CITY PLAN COMMISSION**THURSDAY, FEBRUARY 2, 2023****FILE NUMBER:** S223-058**SENIOR PLANNER:** Sharmila Shrestha**LOCATION:** Jefferson Boulevard, east of 14th Street**DATE FILED:** January 5, 2023**ZONING:** IR**CITY COUNCIL DISTRICT: 3 SIZE OF REQUEST:** 136.503-acres **MAPSCO:** 51A**APPLICANT/OWNER:** DGIC, LLC, Duval Semi Trailers, Inc.

REQUEST: An application to replat a 136.503-acre tract of land containing all of Lots 3 and 4 in City Block 222/6113 to create 3 lots ranging in size from 6.193-acre to 63.468-acre on property located on Jefferson Boulevard, east of 14th Street.

STAFF RECOMMENDATION: The request complies with the requirements of the IR Industrial Research District; therefore, staff recommends approval of the request subject to compliance with the following conditions:

PRELIMINARY PLAT

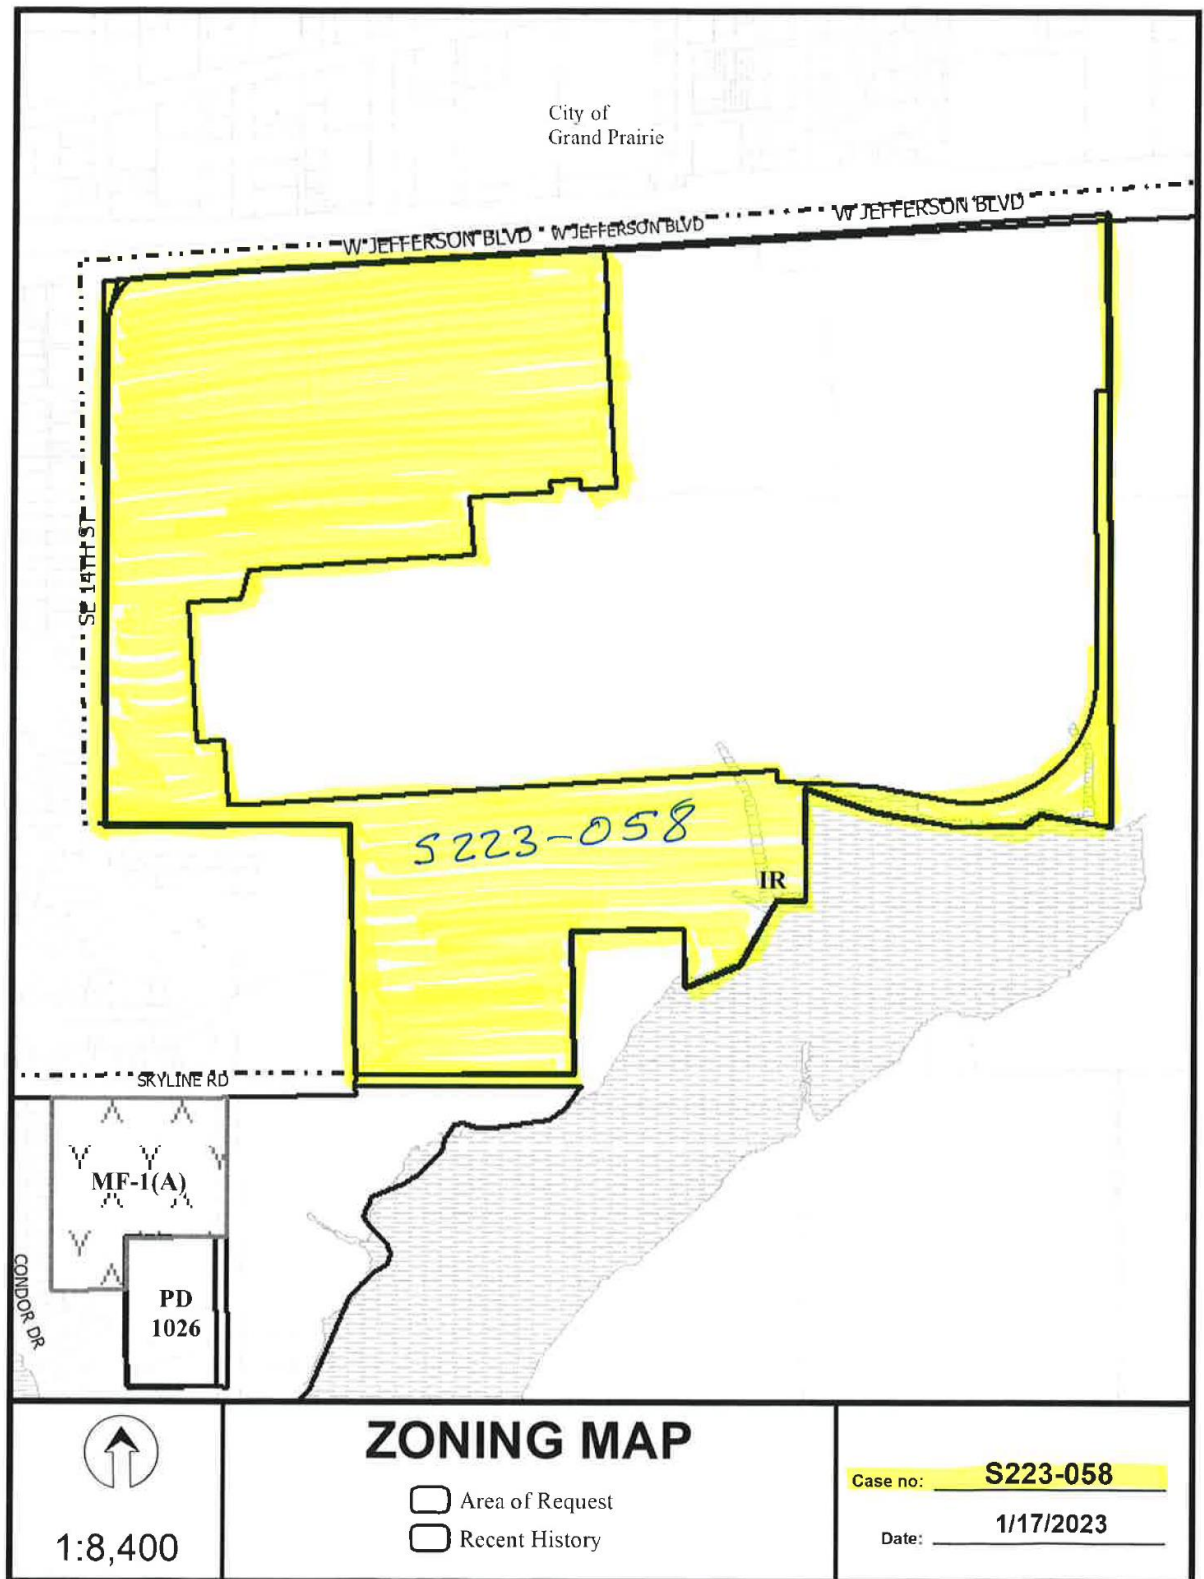
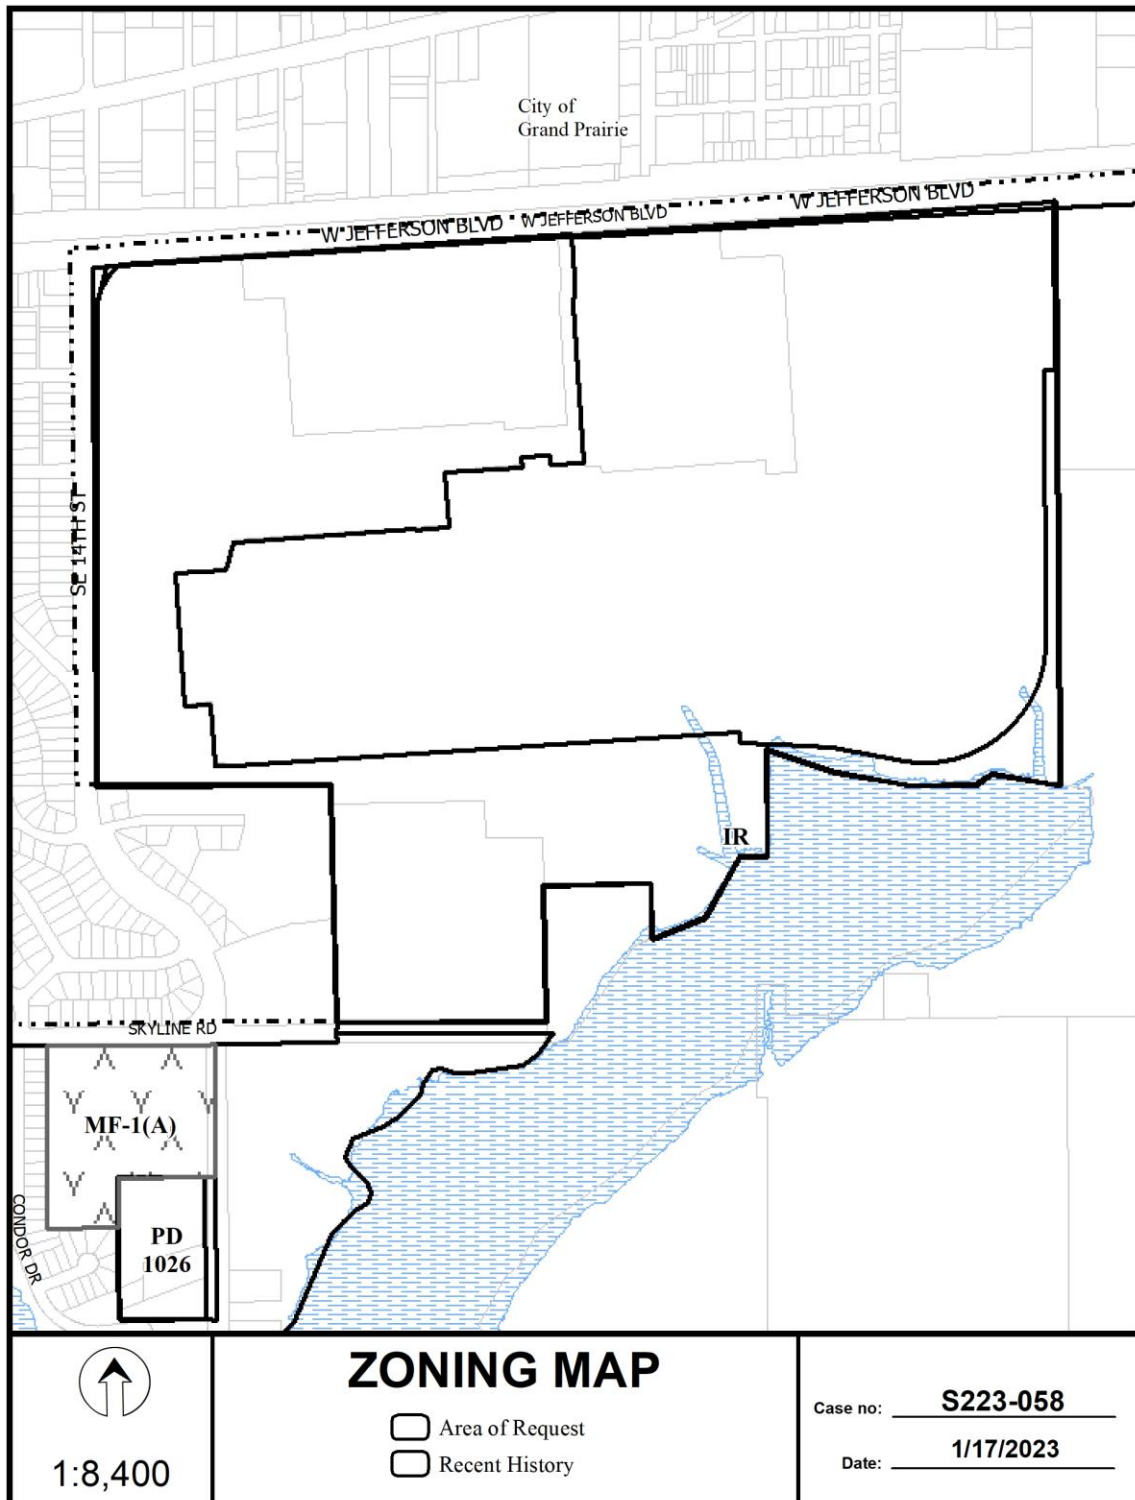
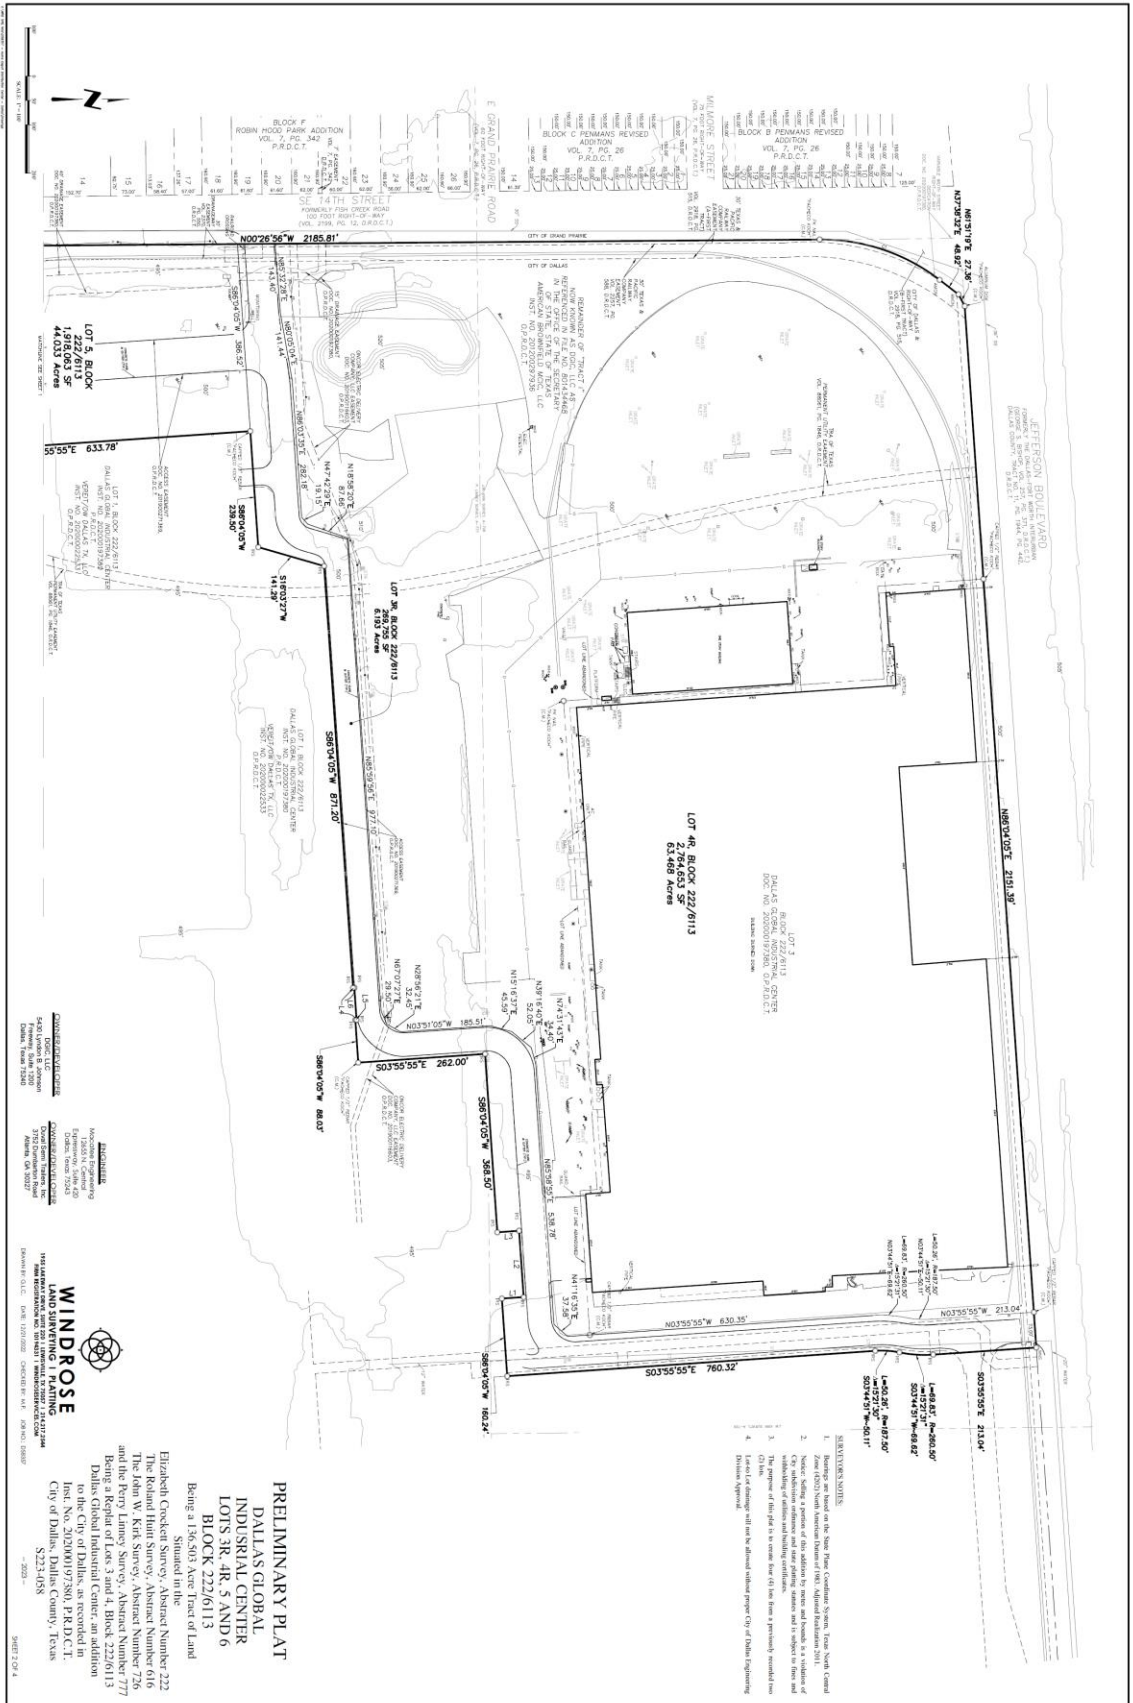
24. Prior to final plat, submit a completed final plat checklist and all supporting documents.
25. On the final plat, show recording information on all existing easements within 150 feet of the property.
26. On the final plat, chose a new or different addition name. Platting Guidelines.
27. On the final plat, comply with minimum text size per City Code 51A-8.403(a)(1)(ii).

28. Engineer must furnish plans for water and sanitary sewer. Developer must furnish a contract for water and sanitary sewer. Sections 49-60(g)(1) and (2) and 49-62(b), (c), and (f).

29. Additional design information is required for assessment. Site plan must be submitted showing proposed development, building finished floor elevation, development, existing mains – including downstream manhole, and proposed water and wastewater service locations. Submit water/wastewater engineering plans to 320 E. Jefferson Blvd., Room 200, Attention: Water and Wastewater Engineering.

30. Wastewater main improvements are required by Private Development Contract. Submit water/wastewater engineering plans to 320 E. Jefferson Blvd., Room 200, Attention: Water and Wastewater Engineering.

31. Existing and any proposed Water and Wastewater Easements must be shown and/or increased to conform to current design standards. **Notice:** Minimum DWU easement size 20' for one utility and 25' for both water and sewer. Larger diameter or deeper mains may require additional width.

32. On the final plat, identify the property as Lots 3A, 4A-4C in City Block 222/6113. Ordinance 1A, Page 131 pages 131-148, Section 2 (passed August 13, 1872).
